Exhibit B-80: Geo-Tech Report:
Response to Skagit County
Geologic Hazard Requirement
(12/16/21)

December 16, 2021
Project No. 20130228E001

Subject: Response to Skagit County Geologic Hazard Requirement
Grip Road Mine Haul Road
Skagit County, Washington

**GEOLOGIC HAZARD
AREAS**

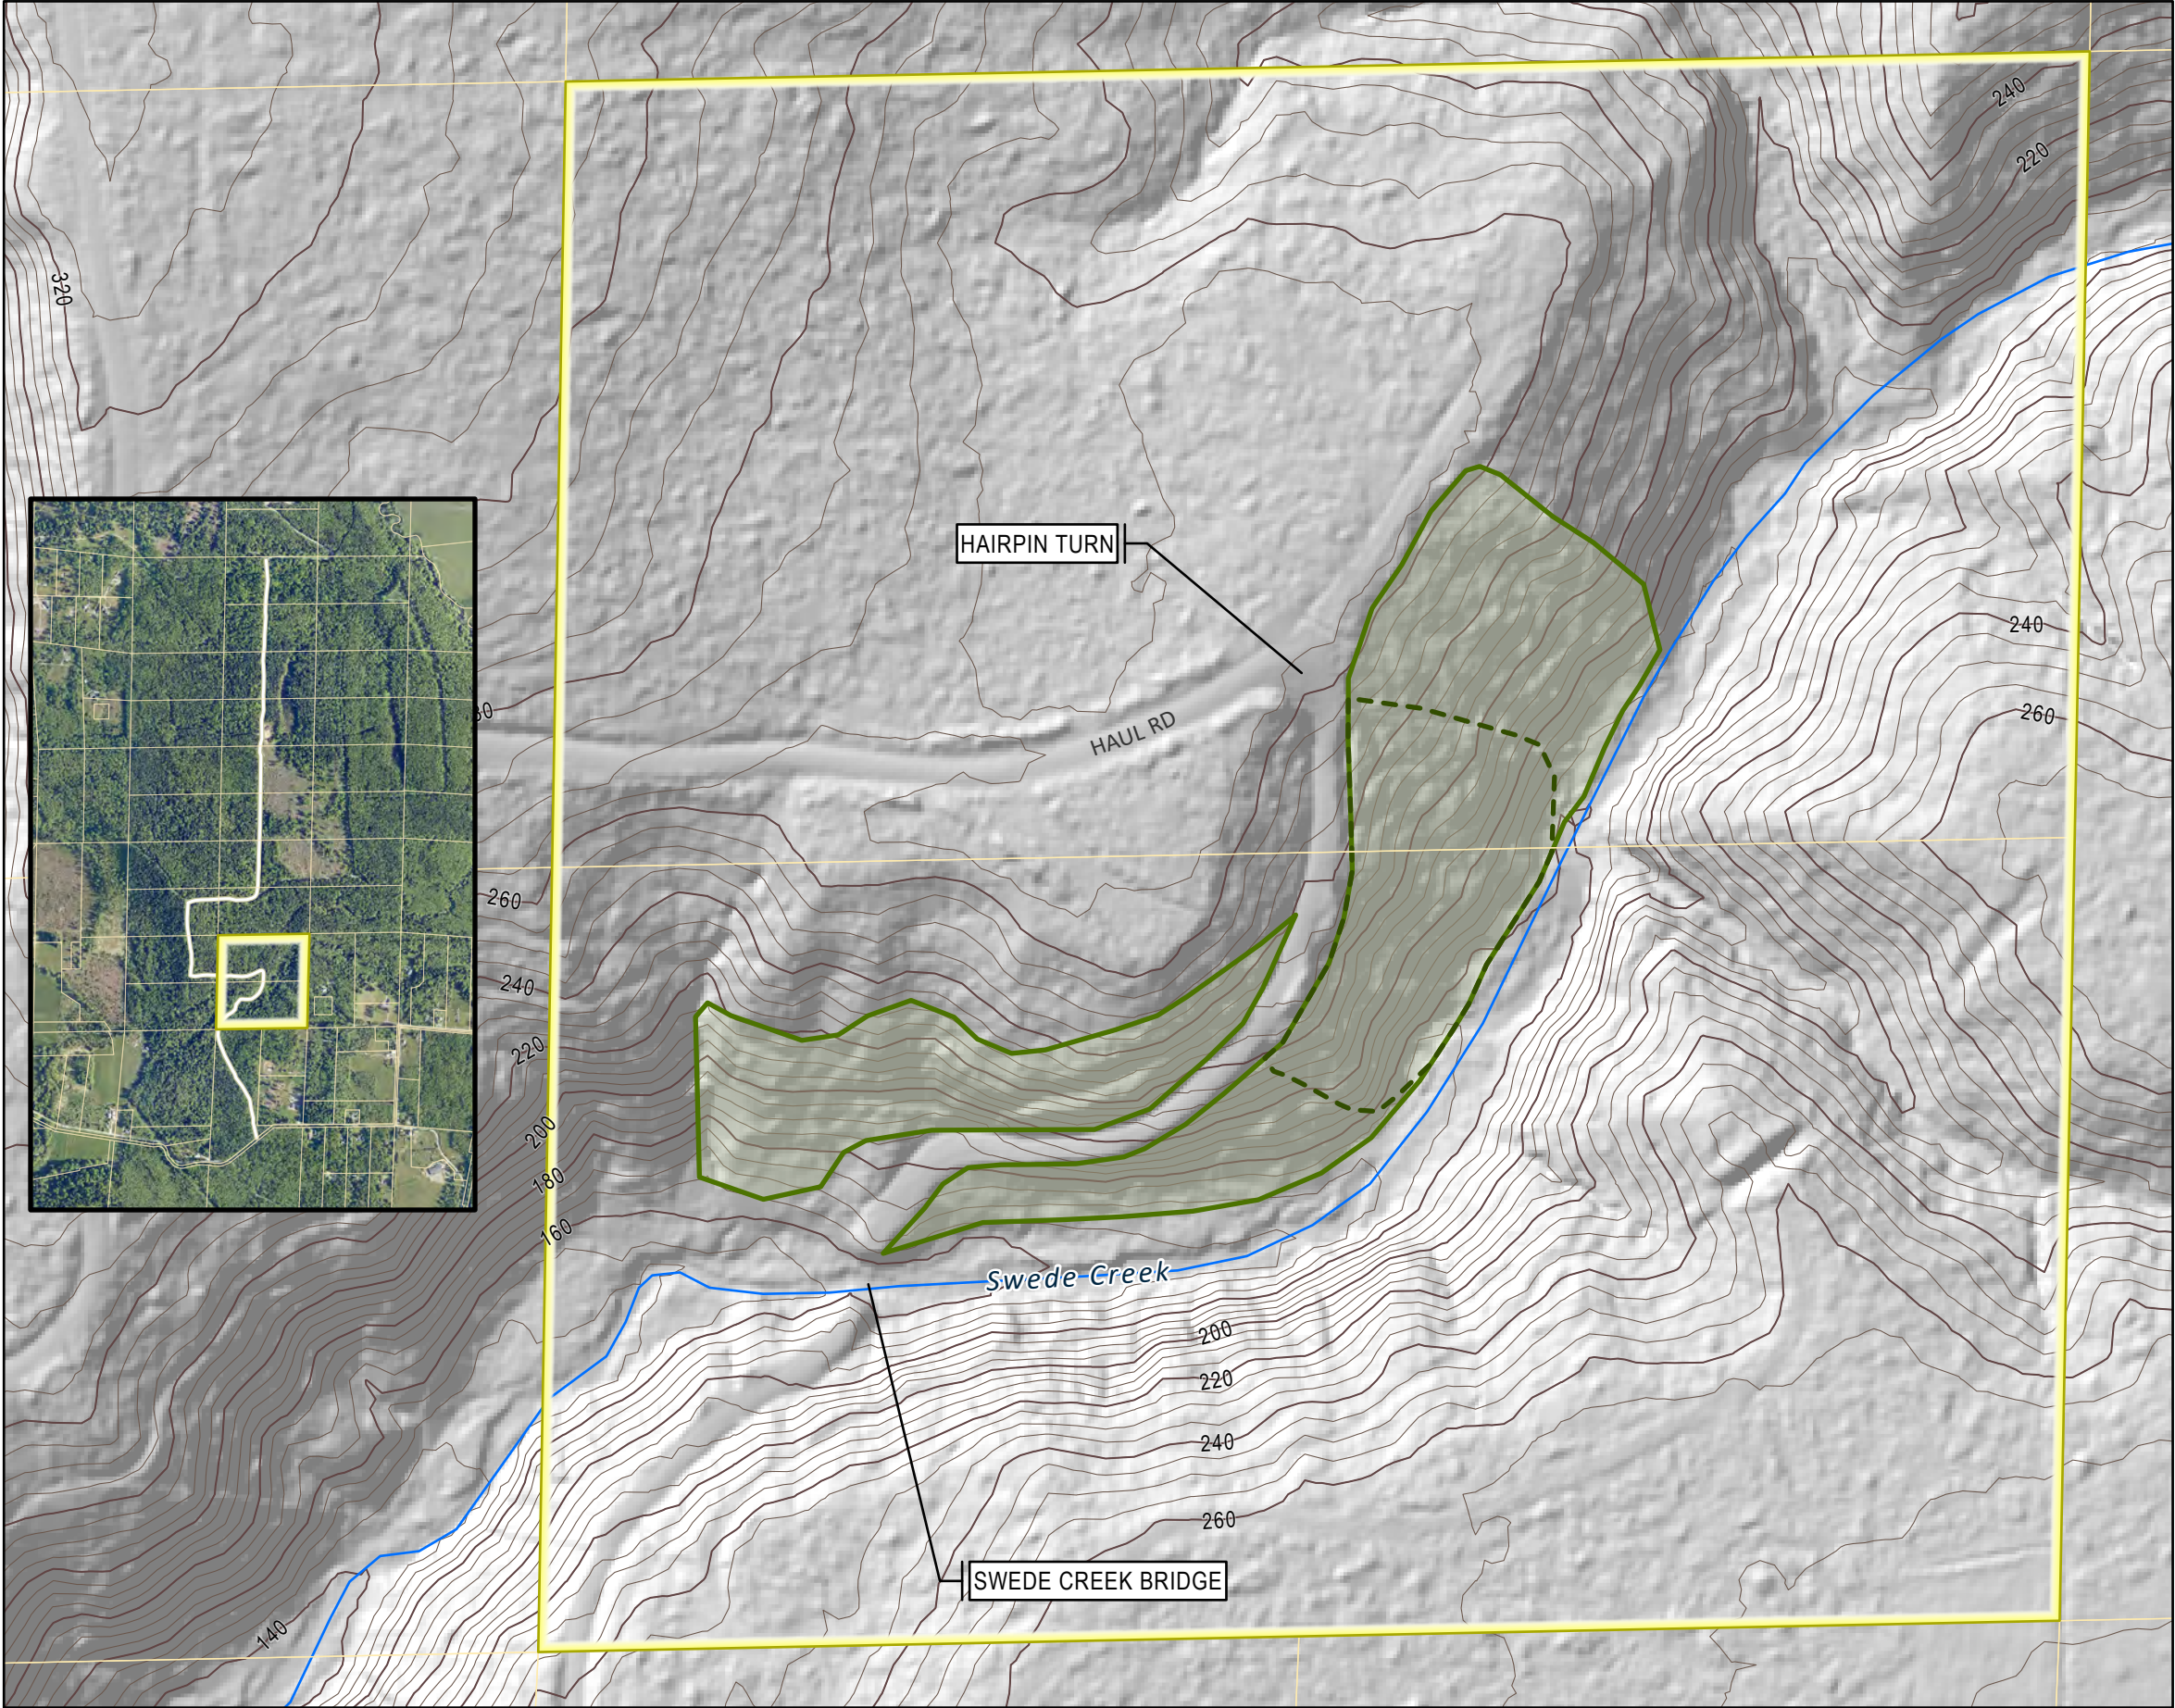
The slope area identified in the County letter as a "geo-hazard," and surrounding slope areas meet the criteria of erosion hazard and landslide hazard areas. Specifically, subsection (a) for erosion hazard area and subsections (c) and (e) for landslide hazard area. Figure 2 shows the extent of the geologic hazard areas in this location. Due to the presence of potential geologic hazard areas, the County is requiring a geologic hazard site assessment per subsection 14.24.080(4) of the SCC. The site assessment requirements which are listed below, require an assessment of impacts to critical areas from the proposed development. The project does not propose any new development, structures, grading, mining, stripping, etc. outside of the limits of the existing haul road. The project will add asphalt surfacing to an approximate 500-foot length of haul road starting near the Swede Creek bridge and extending to the north. A recent ruling by the Skagit County Hearing Examiner states:

Figure 2 attached to this letter provides a site plan showing the geologic hazard critical area. Note the development area consists of an existing haul road. The project does not propose any new grading, structures, clearing, stripping, or mining outside of the limits of the existing haul road. New asphalt surfacing will be added to a roughly 500-foot-long portion of the existing haul road starting at the Swede Creek bridge and extending north.

Figure 2 identifies the critical area adjacent to the haul road.

As previously stated, no alteration to the landslide hazard and erosion hazard areas, or within 300 feet of these areas, through grading, stripping, or other construction activities are proposed. The proposed “development” consists of using an existing haul road to transport aggregate from the proposed gravel mine to Grip Road. This same haul road was used in the past to transport harvested logs from the surrounding area. Based on our site observations, the portion of the haul road in the vicinity of the geologic hazard areas generally appears to have performed well during past logging operation and is generally in good condition. We saw no significant indicators of road instability, or instability to the adjacent slopes. Based on our field observations, the mapped presence of high-strength glacially consolidated sediments at the steep slopes, and the lack of moderate- to deep-seated instability indicators it is our opinion that the use of the road for mining operation will not increase the risk of landsliding or erosion at or near the identified geologic hazard areas.

1. No clearing of vegetation within the geologic hazard areas.
2. Maintain roadside swales and check dams. Clean out material that has sloughed into the swale that could potentially block surface water. Avoid concentrated surface water discharge onto the steep slopes.
3. Do not place uncontrolled fill, strippings, or other debris over the top of steep slopes.
